**Shrewsbury West Sustainable Urban Extension - Welshpool
Road**

Transport Issues Technical Note

**Shropshire Council
October 2010**

Appendix A - Assessment of Five Arm Roundabout Option for Churncote Island junction

Drawing Number: 1023131-P-030 Revision: C

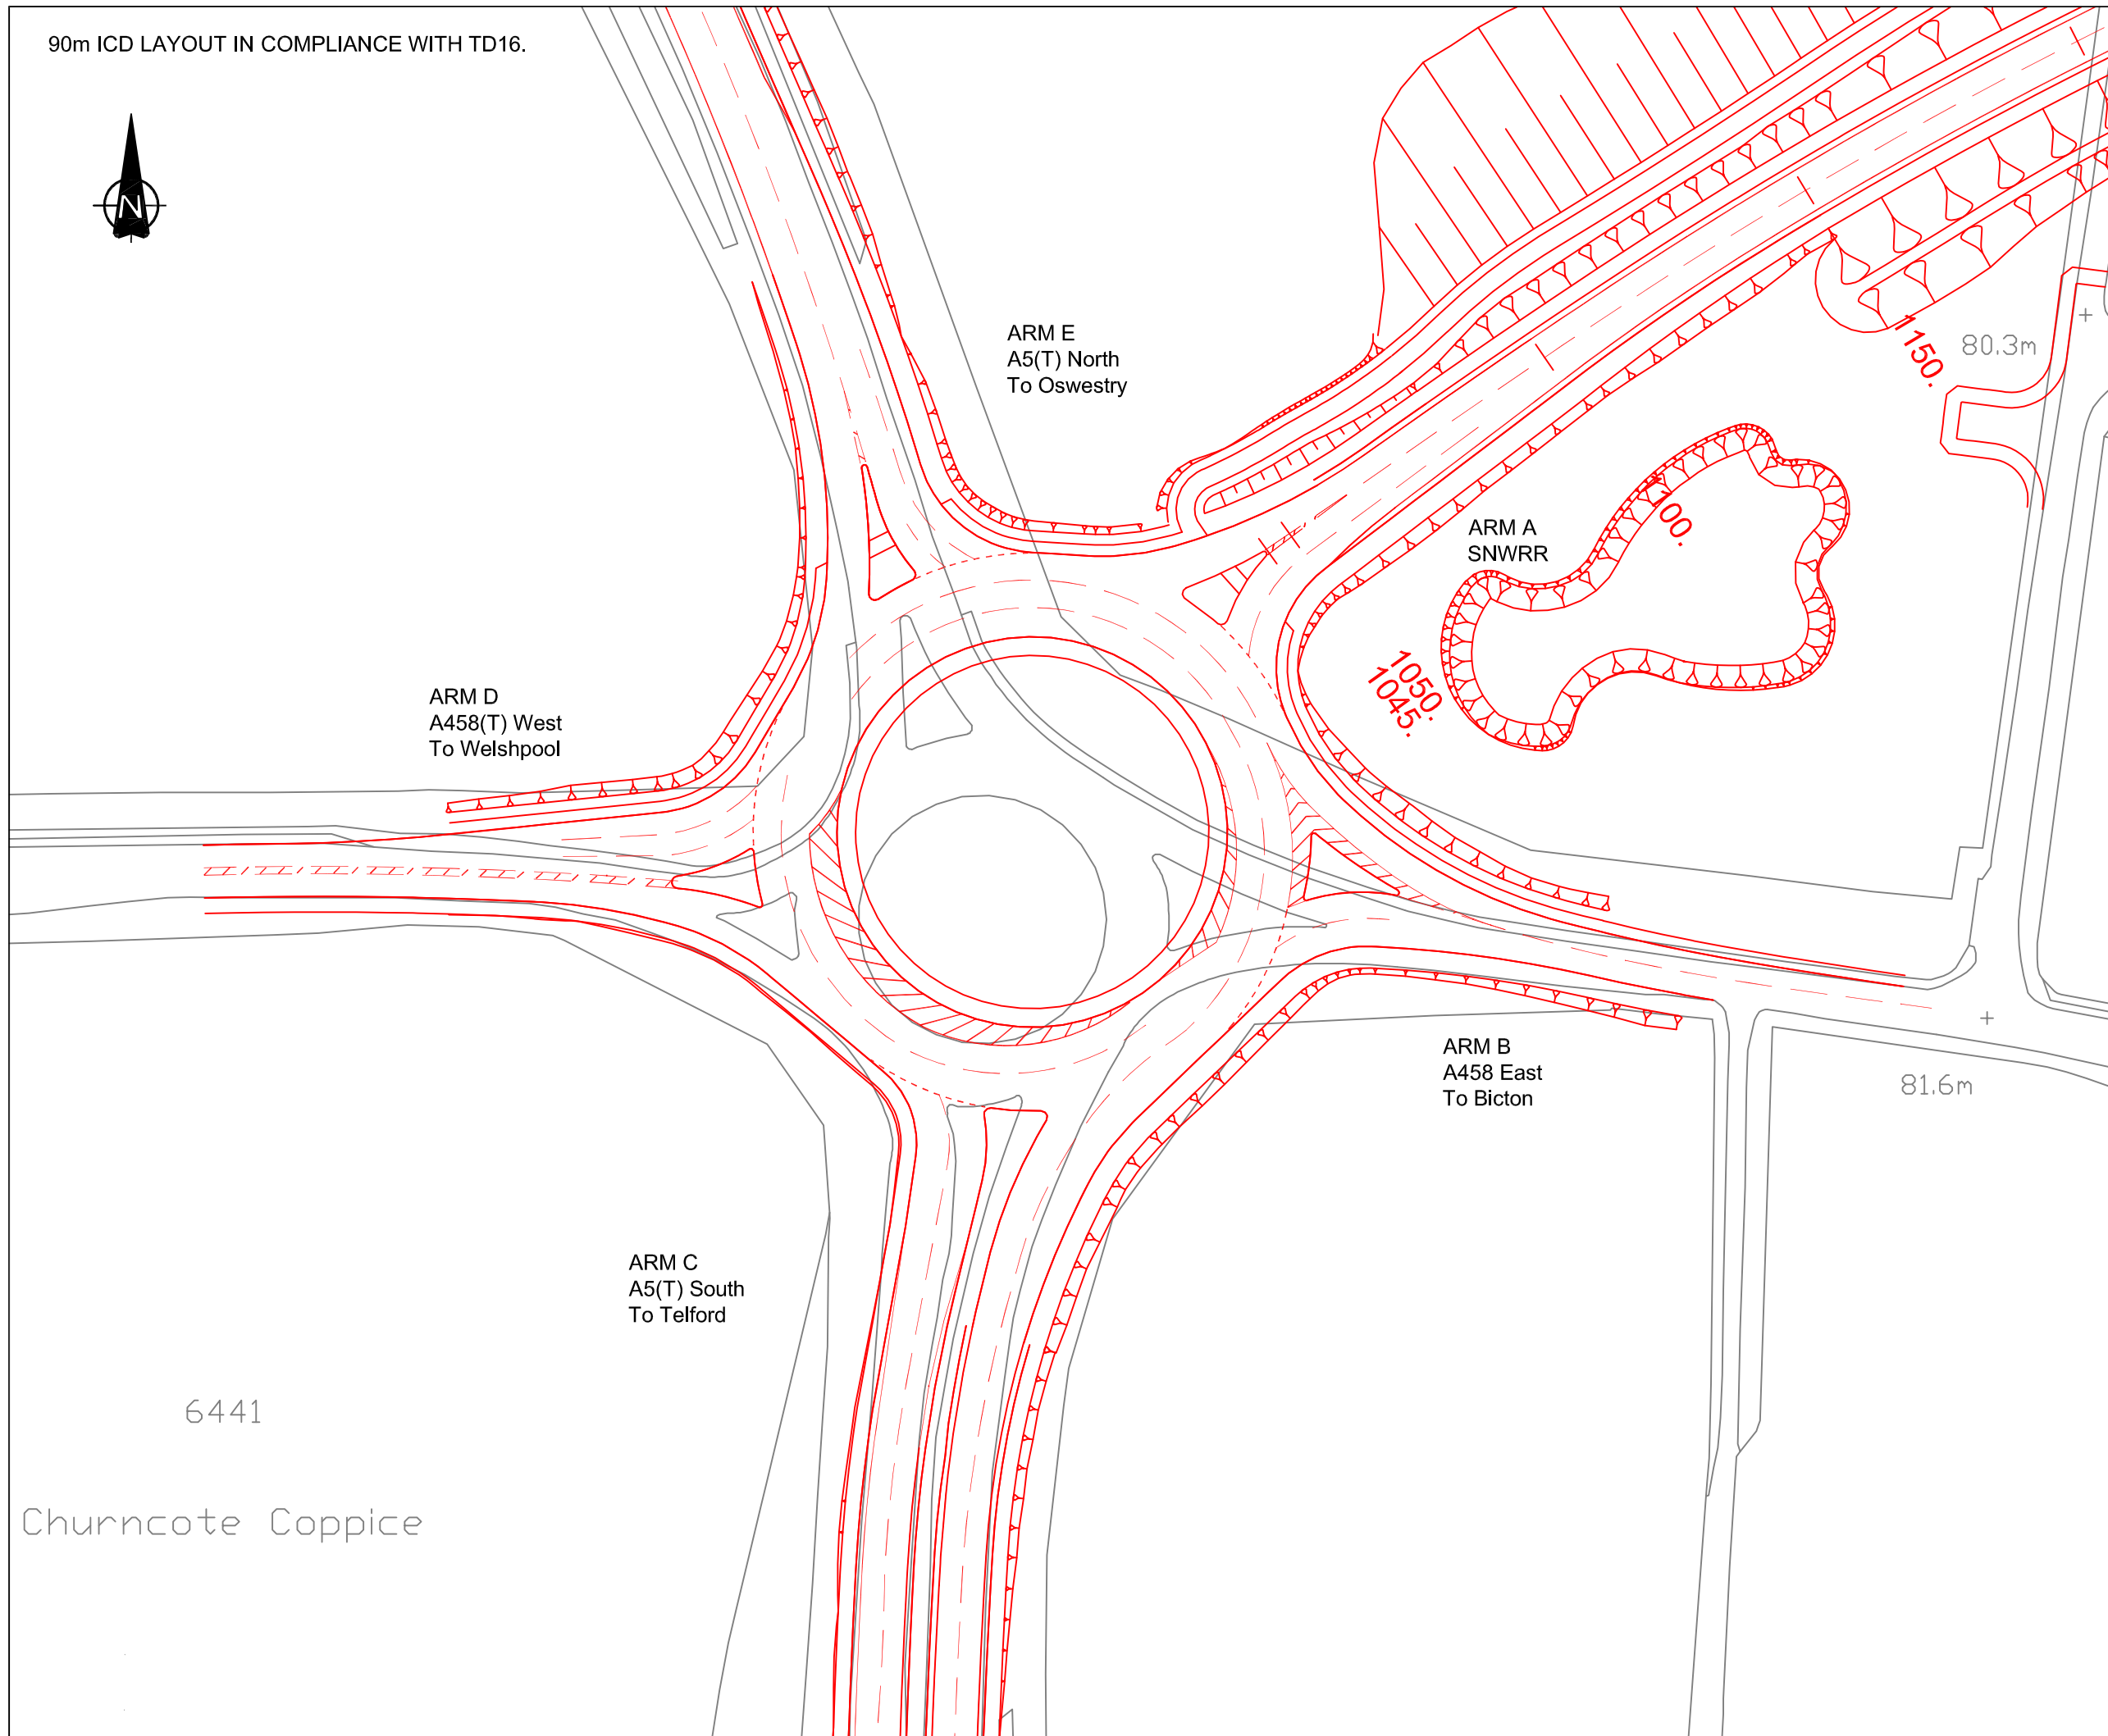
As shown above, there are differences between the two sets of modelling outputs. In respect of the Highways principle concerns, the revised modelling undertaken by JMP appears to demonstrate that the two A5 approaches to the junction (arms B & D) operate in excess of the theoretical threshold of 0.85 RFC, albeit with relatively limited levels of queuing. It should also be recognised that this represents there is considerable amount of benefit from the junction improvement proposal when compared against the 'Do Minimum' option testing.
